SUSQUEHANNA SES UNIT 1 CYCLE 6

TECHNICAL SPECIFICATION
CHANGES

June 1990

PENNSYLVANIA POWER & LIGHT COMPANY

**MAXIMUM AVERAGE PLANAR LINEAR HEAT
GENERATION RATE (MAPLHGR) VERSUS
AVERAGE BUNDLE EXPOSURE
ANF 8X8 FUEL
FIGURE 3.2.1-1**

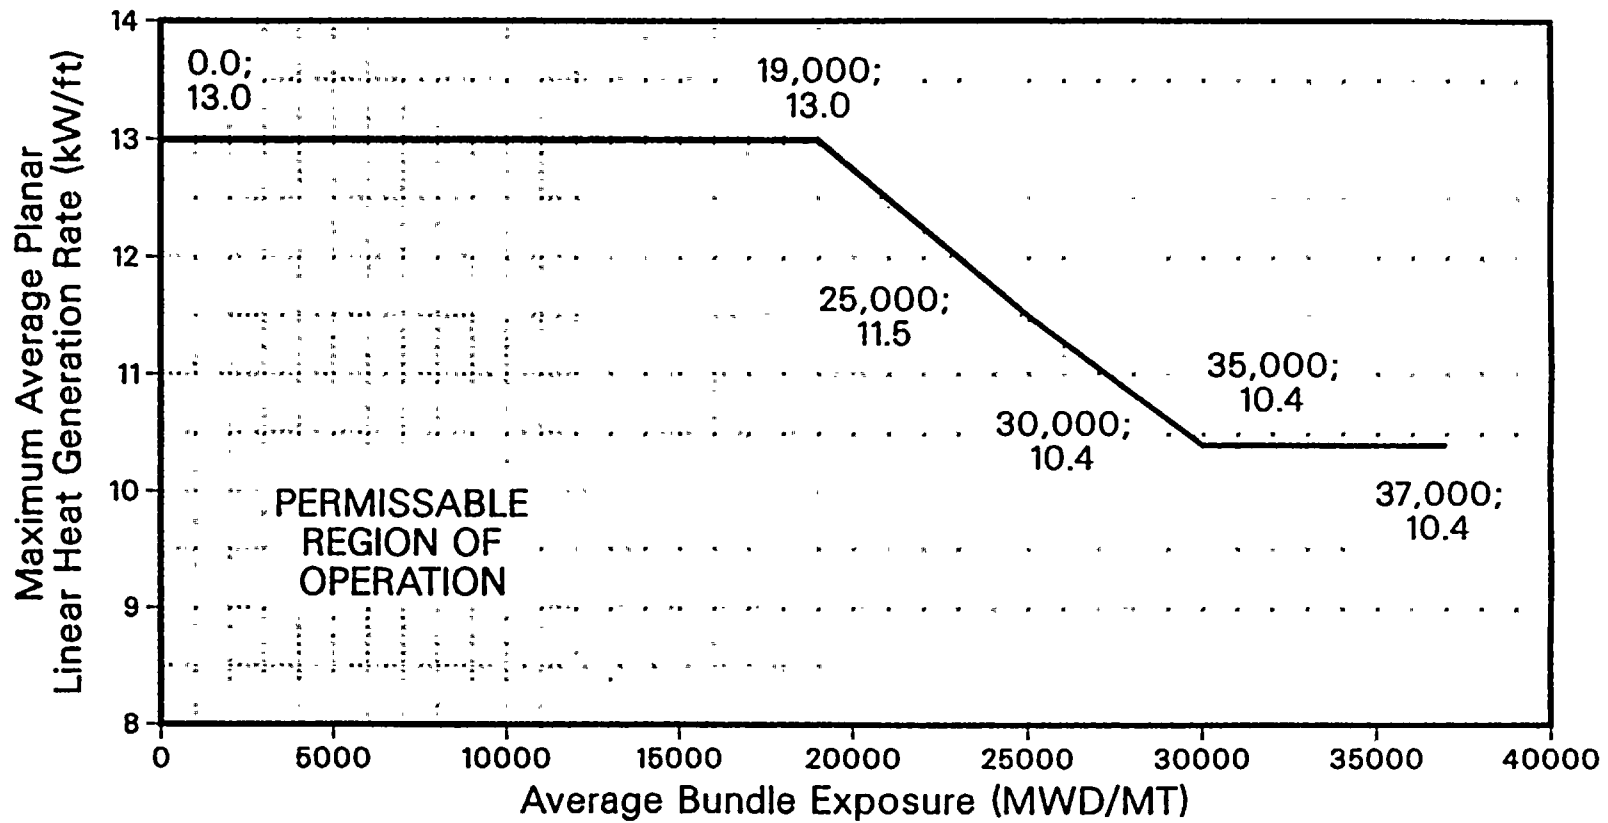
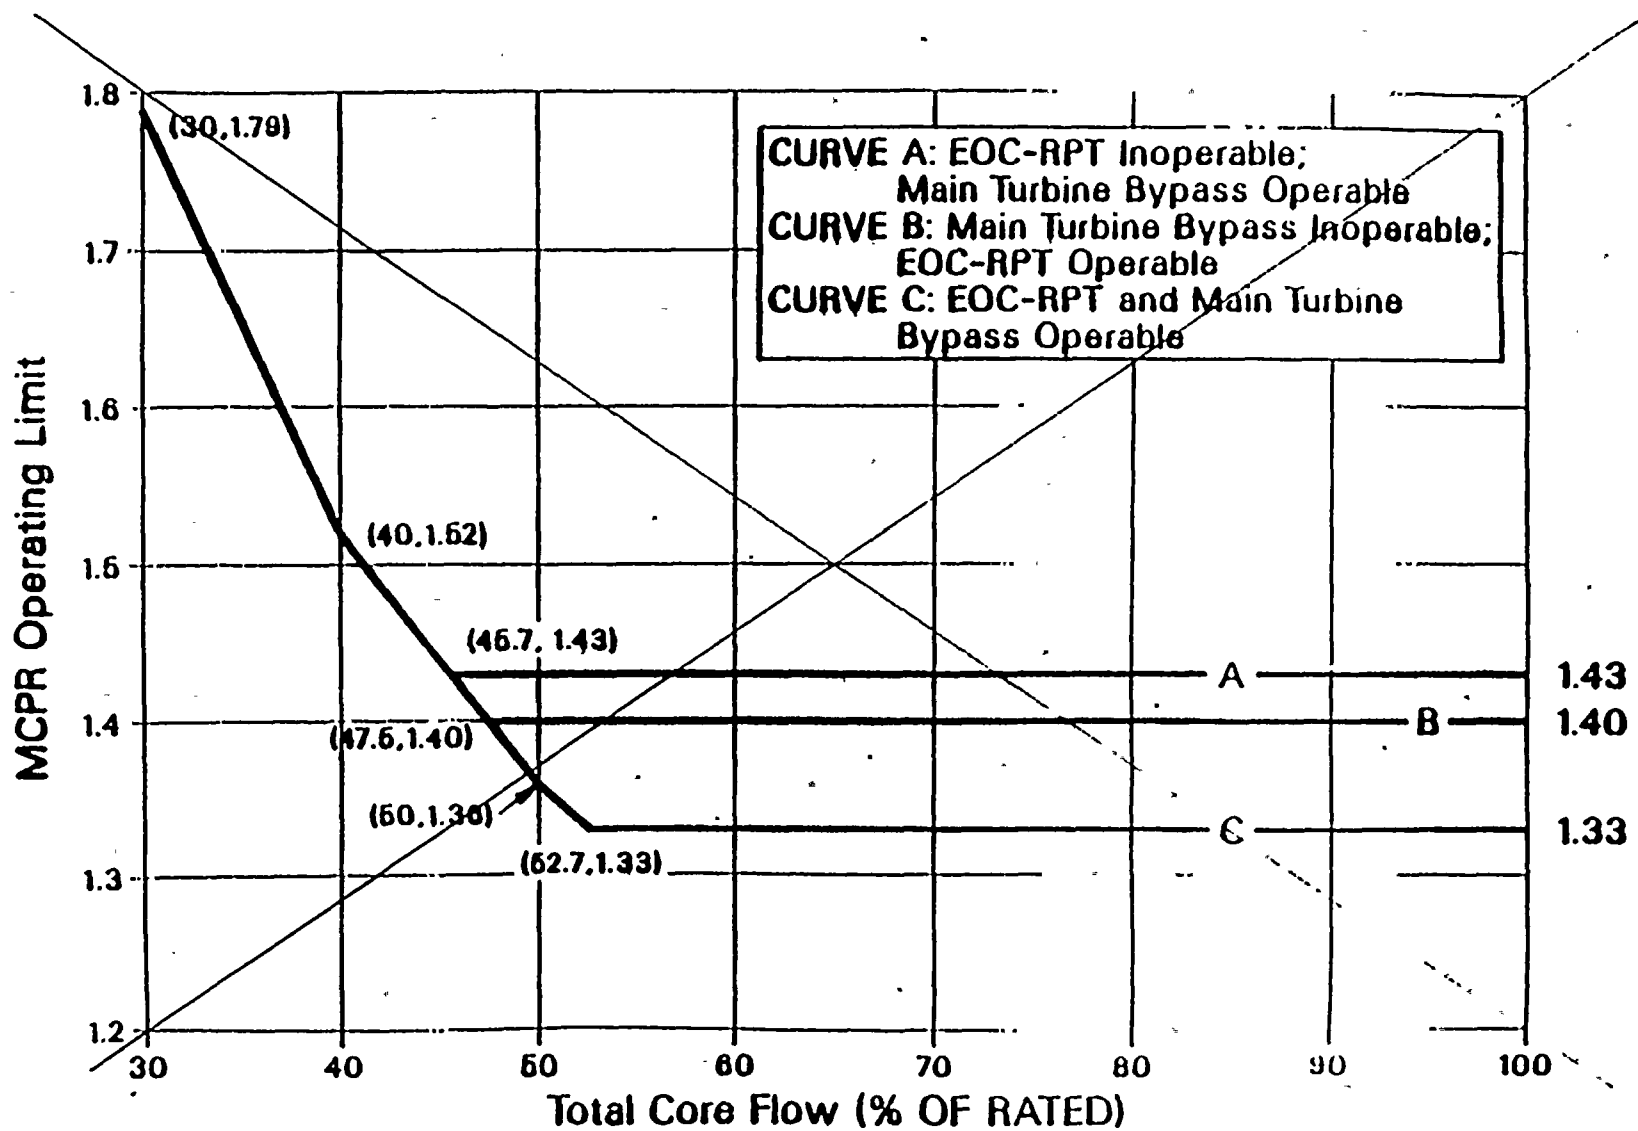
Replace with figure on following page

The changes to this specification are solely to Figure 3.2.1-1, which provides appropriate MAPLHGR limits to bound the exposure that the ANF 8x8 fuel will experience during Cycle 6 operation.

1. No. The increased allowed exposure is based on an additional MAPLHGR evaluation performed by ANF (See Summary Report Reference 3). This evaluation is consistent with previously approved methods, and ensures that the peak cladding temperature for the ANF 8x8 fuel remains below 2200°F, local Zr-H₂O reaction remains below 17%, and core-wide hydrogen production remains below 1% for the limiting LOCA event as required by 10 CFR 50.46. Therefore, the additional MAPLHGR limits do not involve a significant increase in the probability or consequences of an accident previously evaluated.

FLOW DEPENDENT MCPR OPERATING LIMIT
FIGURE 3.2.3-1

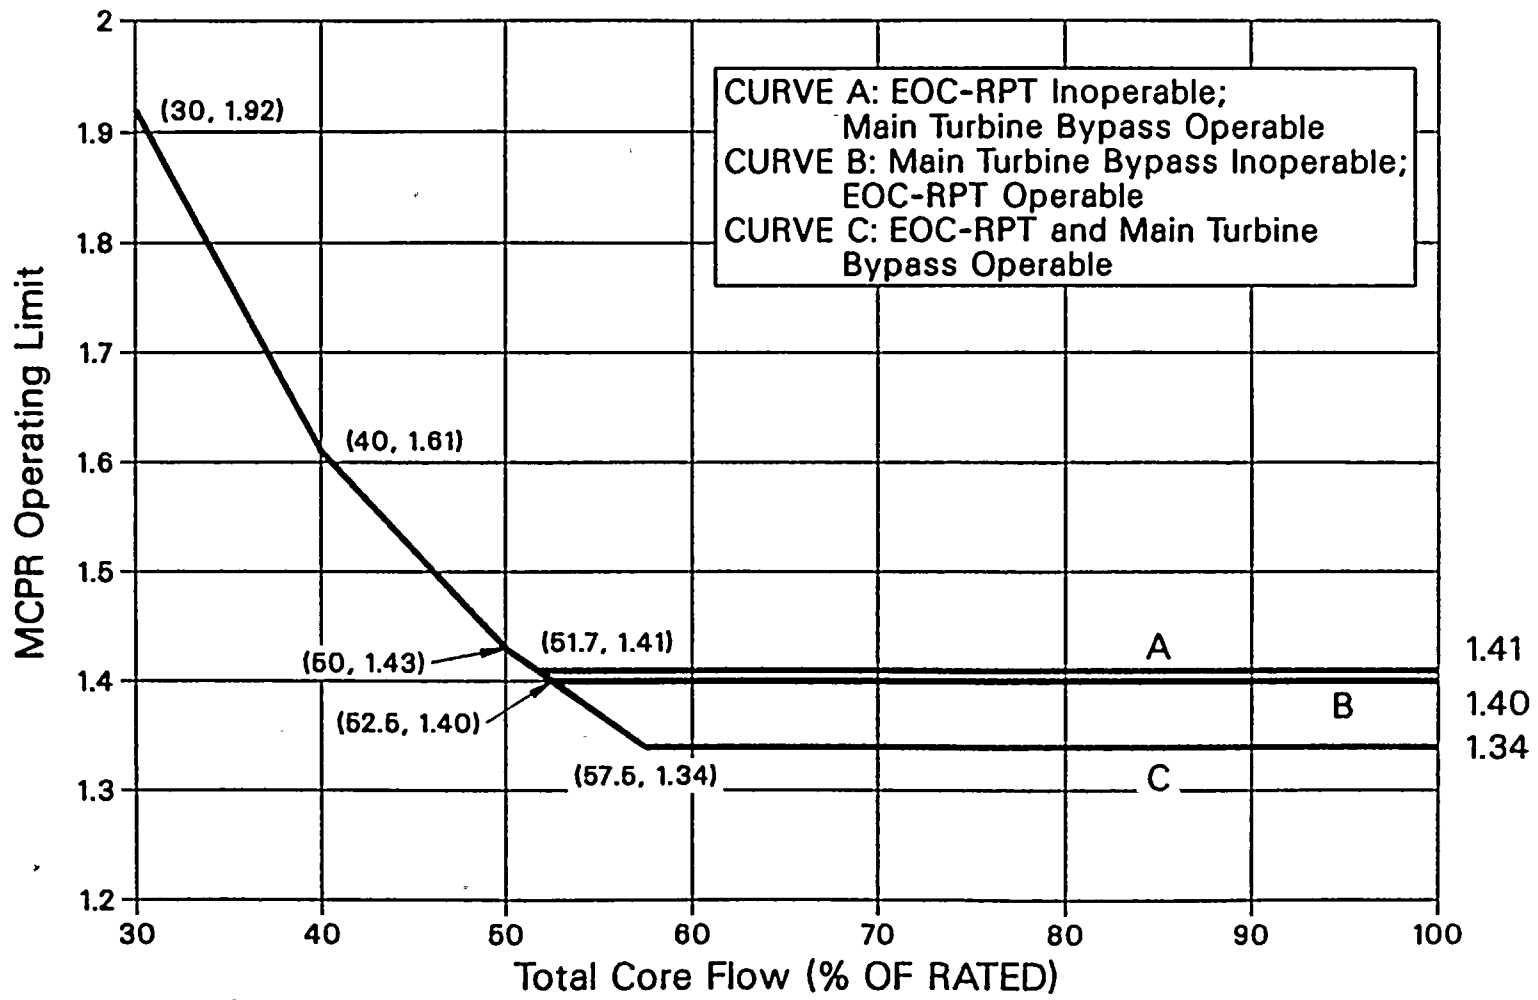
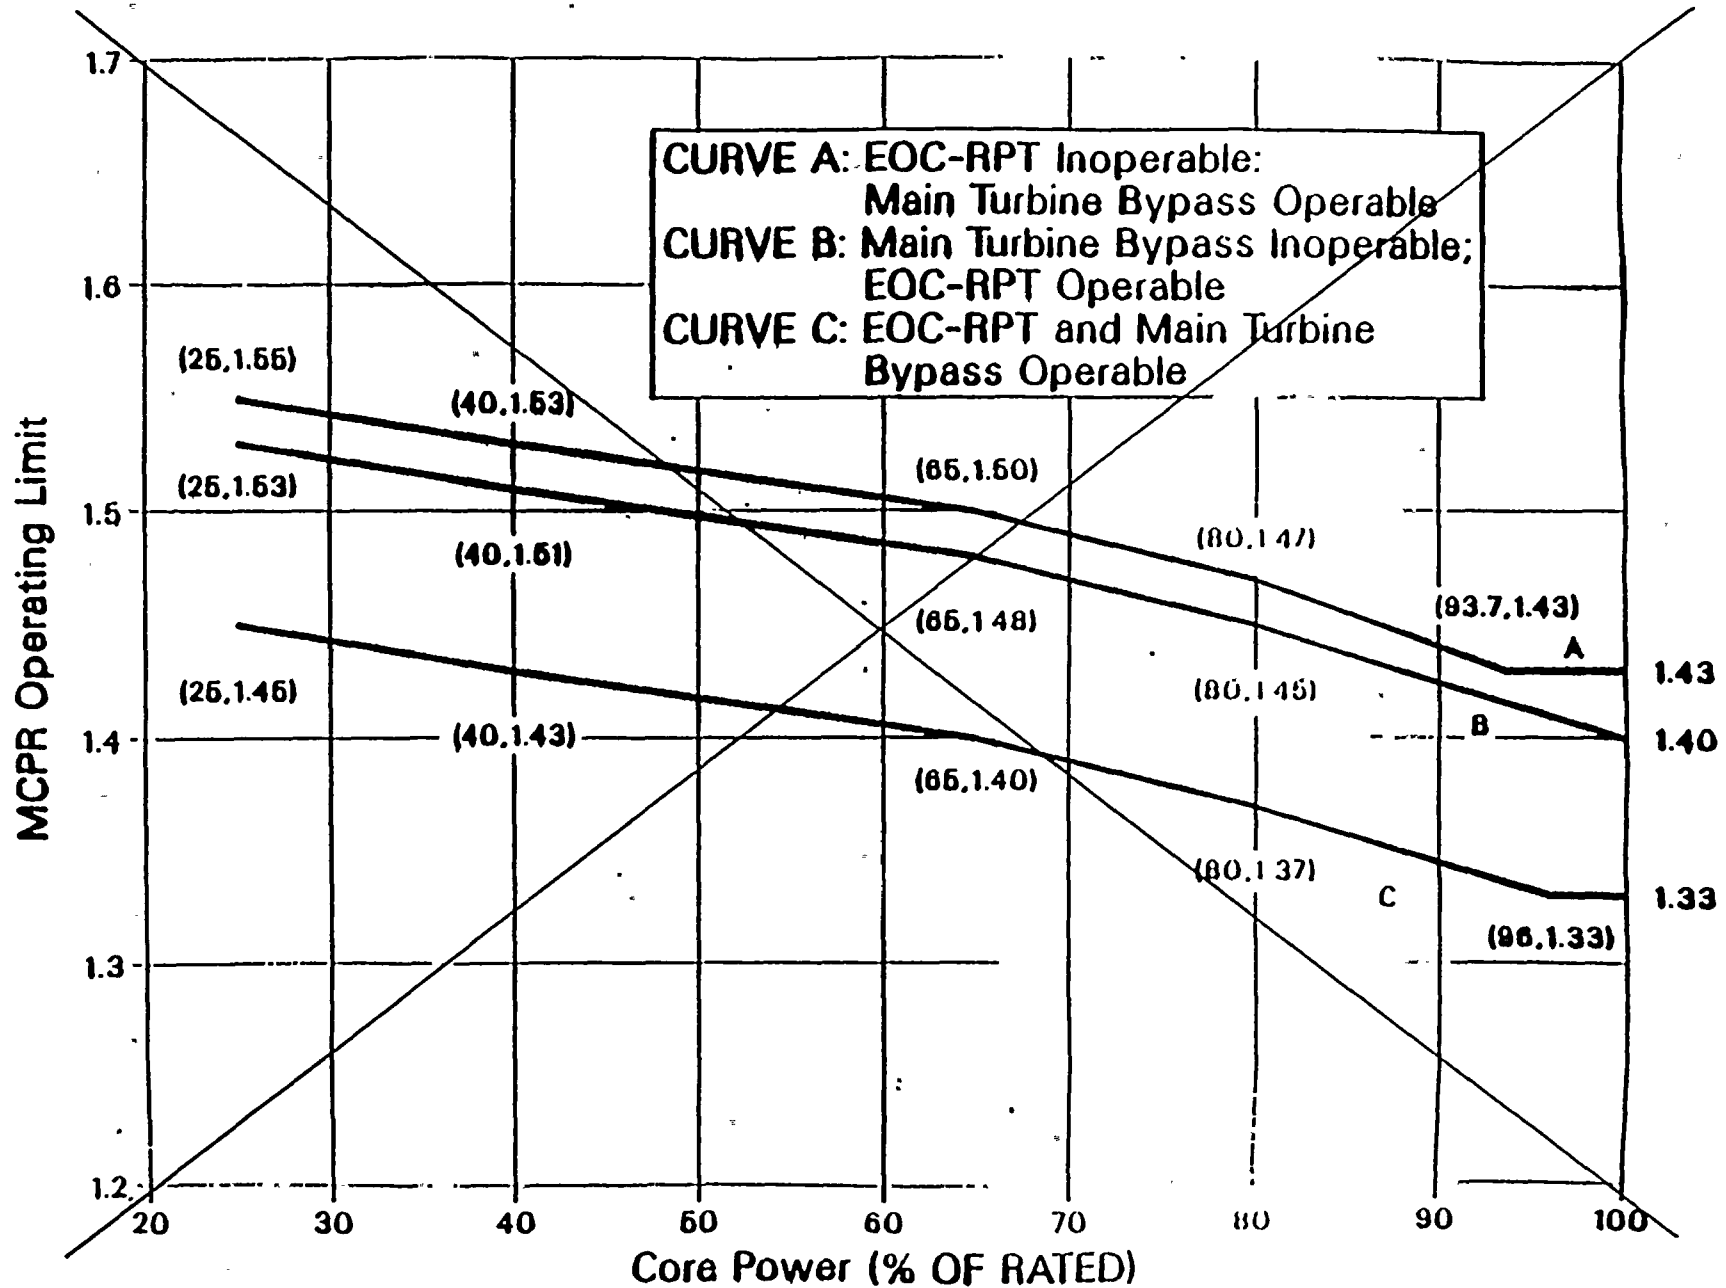
Replace with figure on following page

The changes to this specification provide new operating limit MCPR curves based on cycle-specific transient analyses.

1. No. Limiting core-wide transients were evaluated with ANF's COTRANSA code (see Summary Report Reference 29) and this output was utilized by the XCOBRA-T methodology (see Summary Report Reference 30) to determine delta CPRs. Both COTRANSA and XCOBRA-T have been approved by the NRC in previous license amendments. All core-wide transients were analyzed deterministically (i.e., using bounding values as input parameters).

**LINEAR HEAT GENERATION RATE (LHGR) LIMIT
VERSUS AVERAGE PLANAR EXPOSURE
ANF 8X8 FUEL
FIGURE 3.2.4-1**

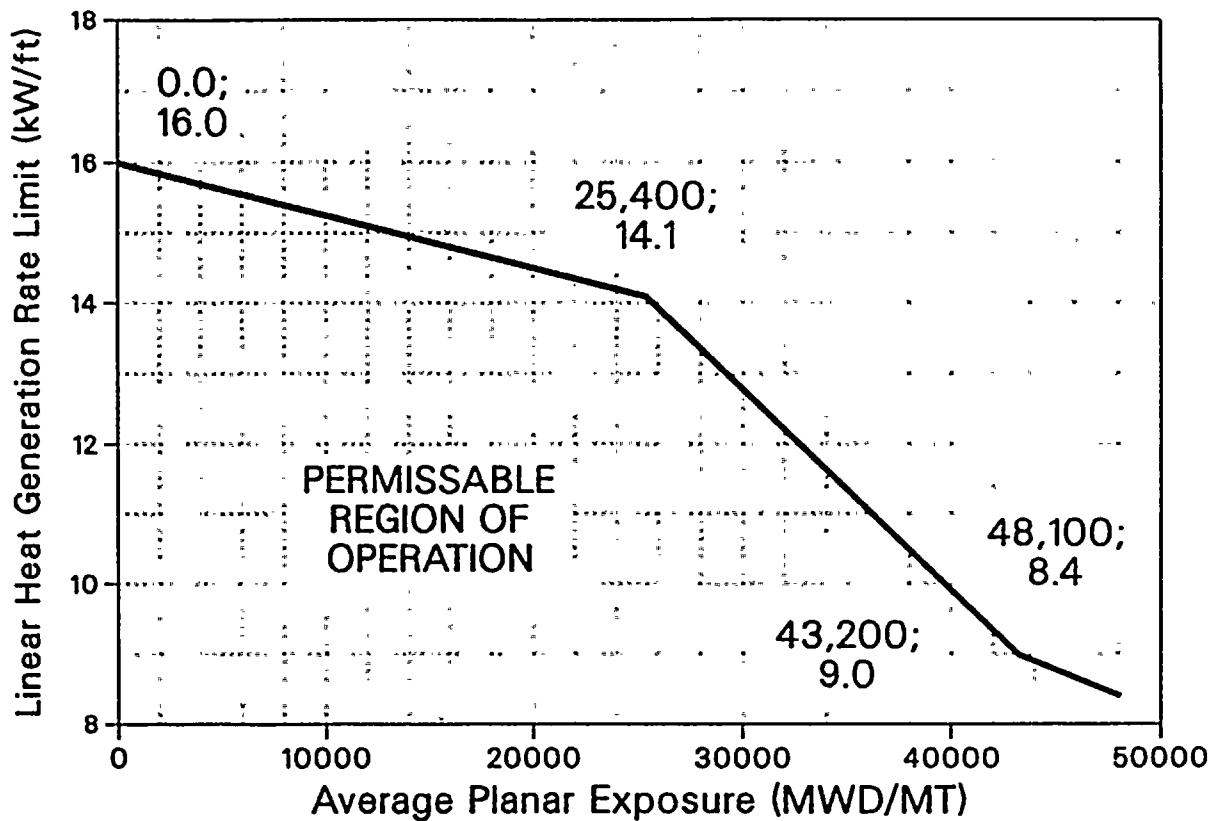
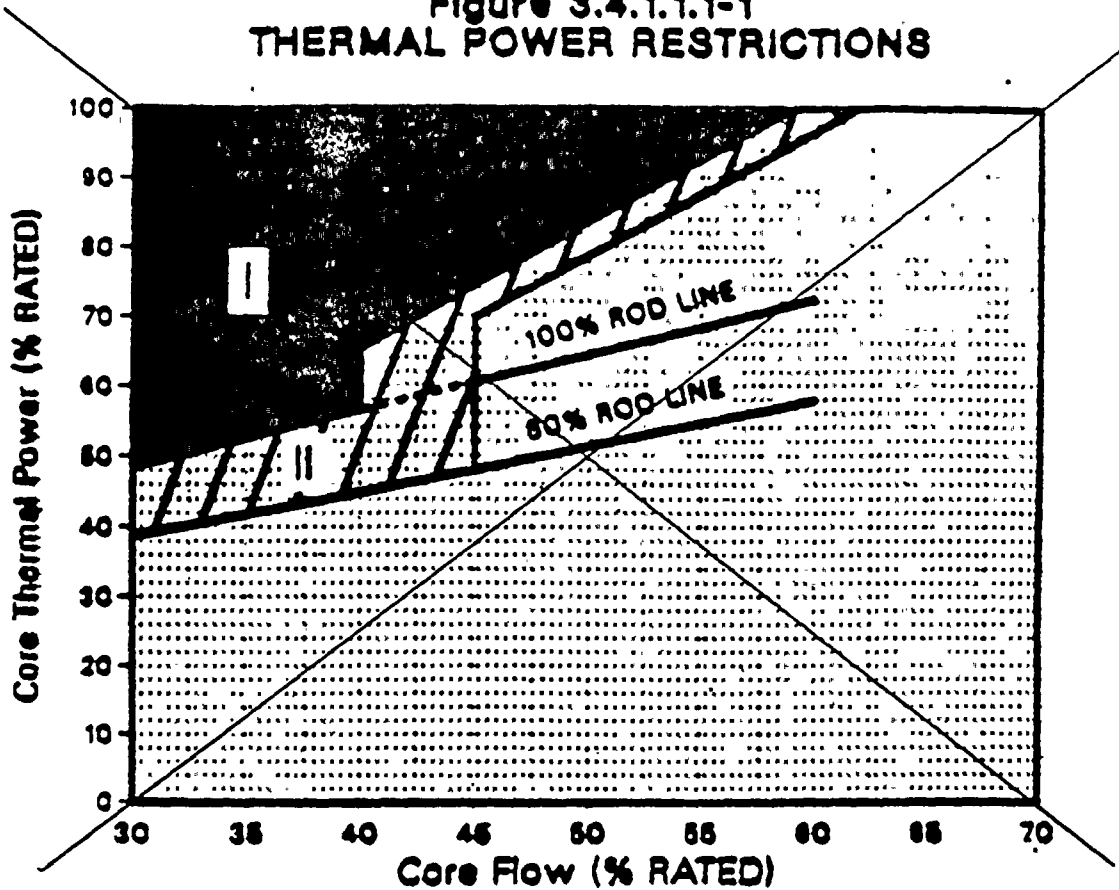
Replace with Figure on Following page

Replace with figure on following page

Proposed changes to this specification provide appropriate limits at extended burnups for ANF 8x8 fuel.

1. No. ANF-90-018(P), Revision 1 (see Summary Report Reference 5) supports the new maximum 8X8 discharge exposure. This report demonstrates that margin to 8x8 fuel mechanical design limits is assured for all anticipated operational occurrences throughout the life of the fuel provided that the fuel rod power history remains within the power histories assumed in the analyses.
